UNITED STATES  
ATOMIC ENERGY COMMISSION  
St. Louis Area Office  
Post Office Box 470  
St. Charles, Missouri  
May 27, 1960

Subject: BULLETIN NO. 4, CONTRACT NO. AT-(23-2)-44 -- DEMOLITION  
OF DESTREHAN STREET PLANT -- MODIFICATIONS TO TECHNICAL  
SPECIFICATIONS AND SPECIAL CONDITIONS APPLICABLE TO BOTH  
ORIGINAL BID AND ALTERNATE PROPOSAL NO. 1

JK-AT-(23-2)-44-A

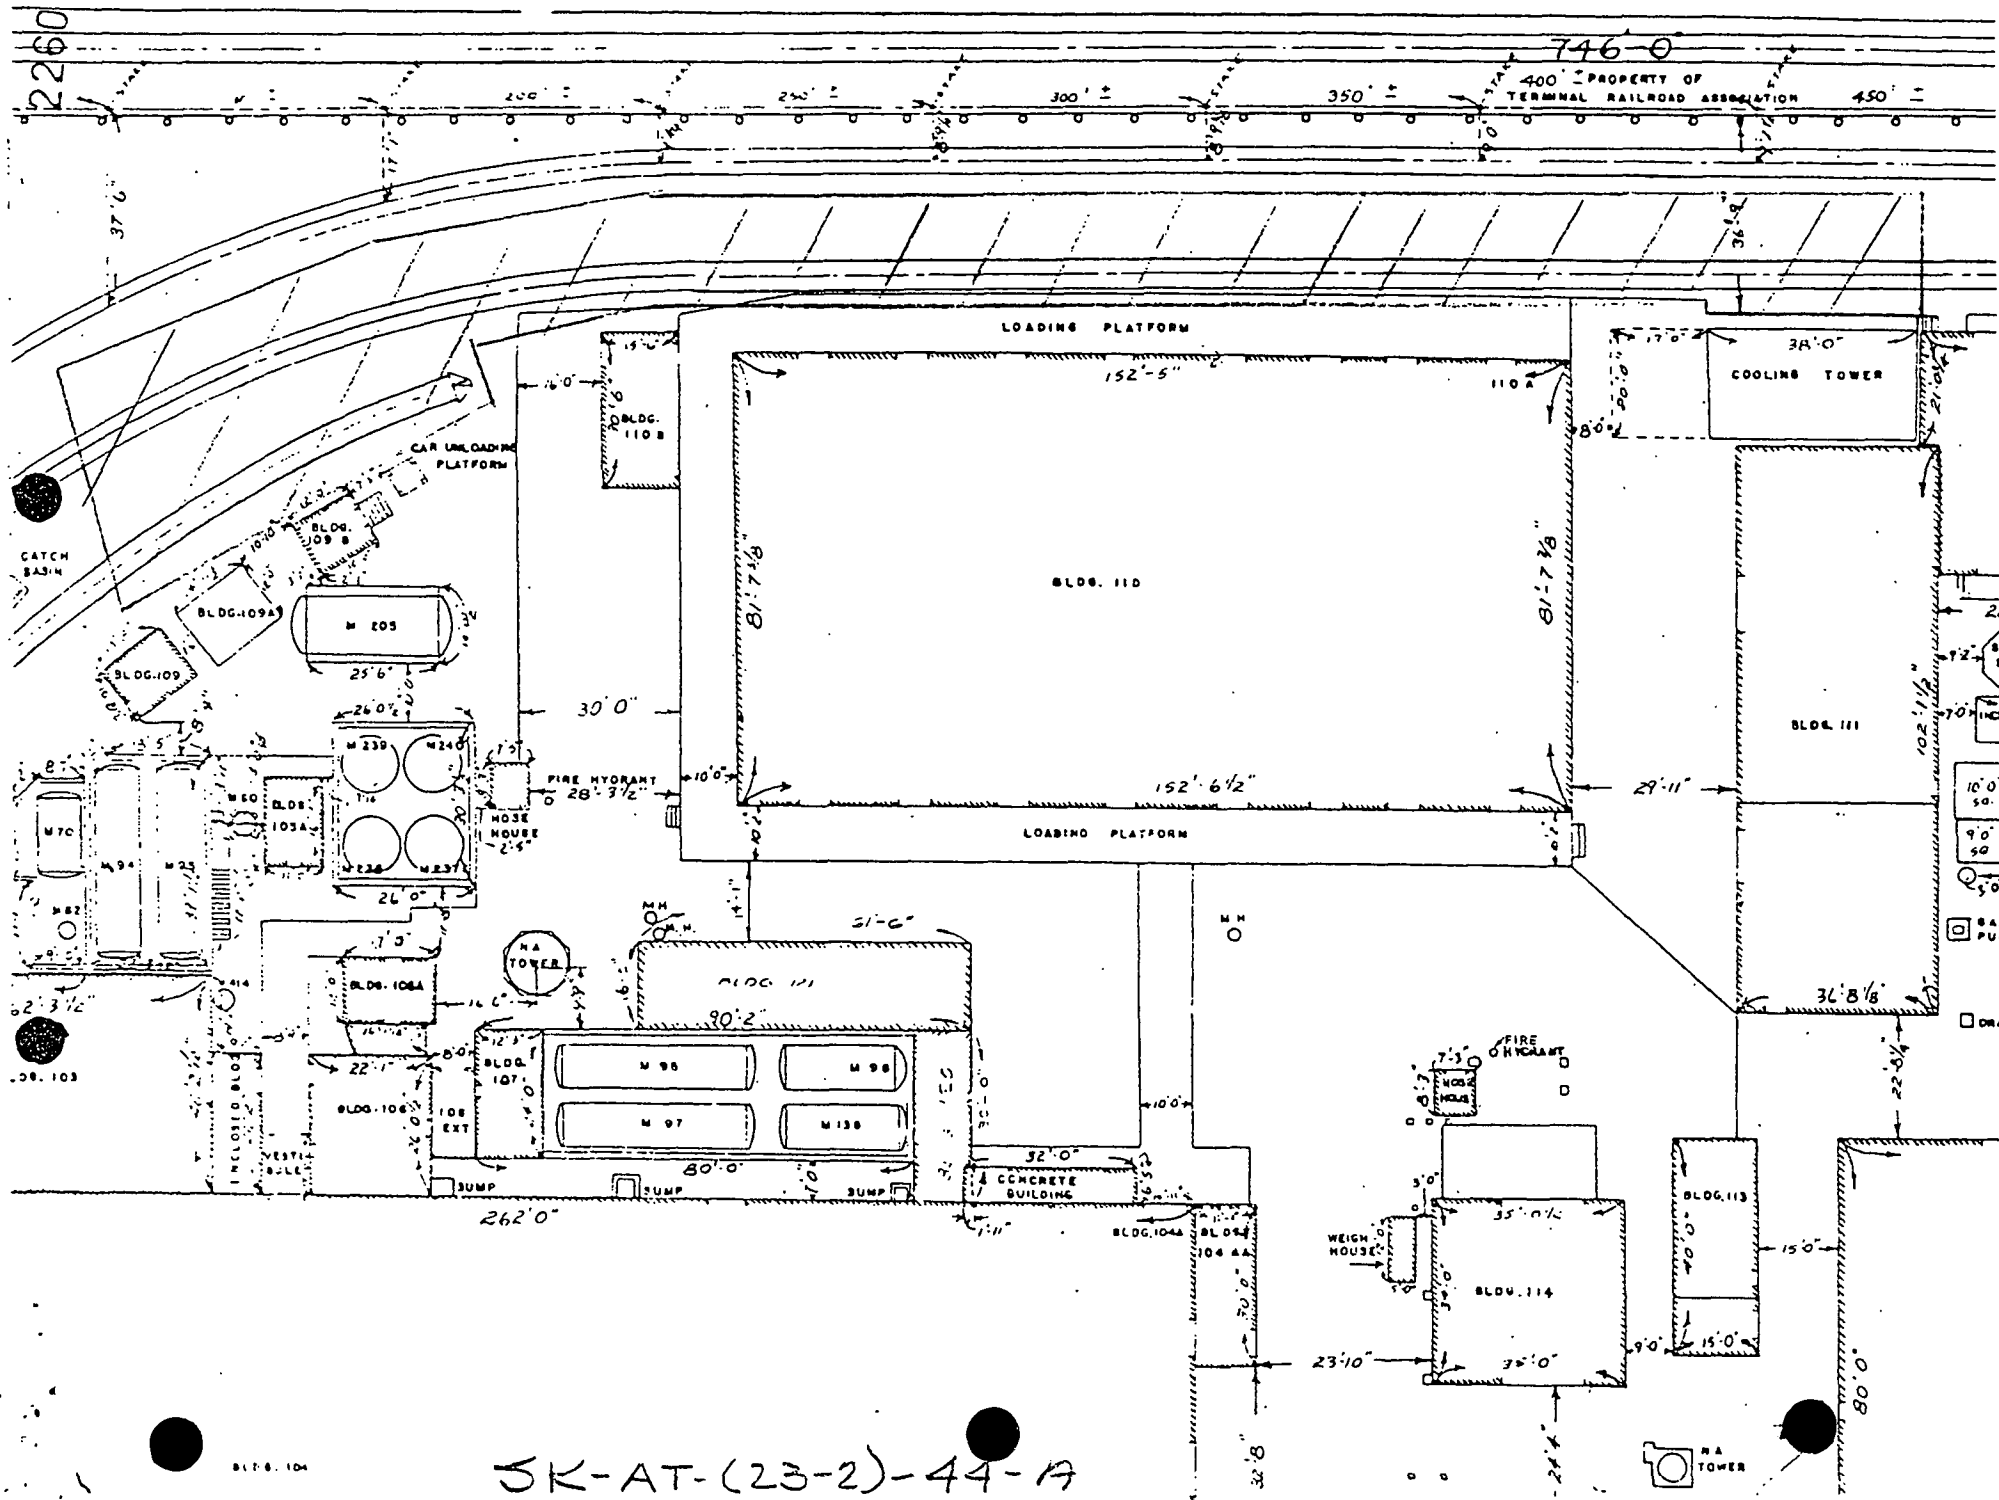
5. The attached two sketches of the Plant 6 and Plant 7 areas of the Destrehan Street Plant show railroad trackage areas which are marked with red crayon cross hatchings that are to indicate the tracks, ballast and earth to be removed and disposed of under terms of this contract. The tracks and associated metal accessories such as nuts, bolts, tie plates, fish plates, etc., are to be disposed of as indicated in Article SC-2 of the Special Conditions and the cross ties, ballast and earth to a four-foot depth are to be removed and disposed of in accordance with other applicable articles of the Technical Specifications and/or Special Conditions. Rail stops are to be reinstalled, and/or new rail stops furnished and installed in locations as directed by the Contracting Officer. Remaining trackage will remain as is, where is.

It is suggested that this track work be performed at the conclusion of the demolition work of this contract.
